Alaska Department of Environmental Conservation

Amendments to: State Air Quality Control Plan

Volume III: Appendix III.K.6 Best Available Retrofit Technology (BART) Documentation

DEC GVEA BART Final Determination Report 2-5-10 (revised 6-1-10)

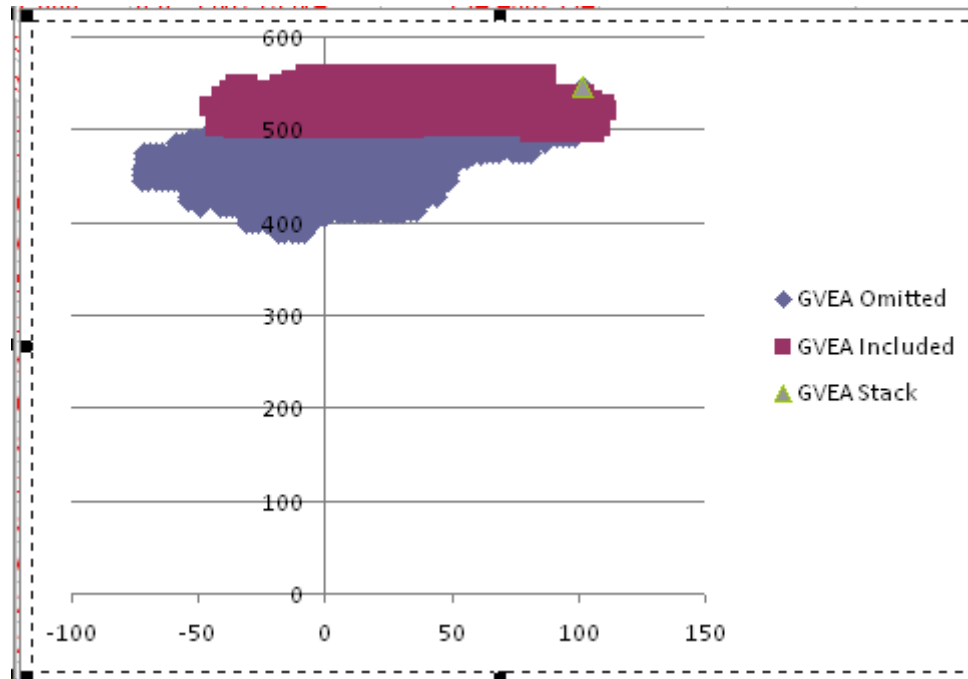
The maximum modeled visibility impact associated with Auxiliary #1 Boiler using corrected maximum NO_x and SO₂ emission rates continues to show this emission unit is not predicted to cause or contribute to visibility impairment at DNP.

It is noted that the Auxiliary #1 Boiler revised maximum visibility impact presented above occurred at a location included in GVEA's visibility modeling analysis. Therefore, the revised

maximum impact is attributable solely to the corrected unit NO_x and SO₂ emission rates. The 776 previously omitted receptors are relatively distant from the Healy Power Station, and the 591 receptors initially modeled by GVEA are located in relatively close proximity to the plant and remain the dominant receptors in this analysis. The figure below shows the locations of these groups of receptors relative to the Healy Power Station.
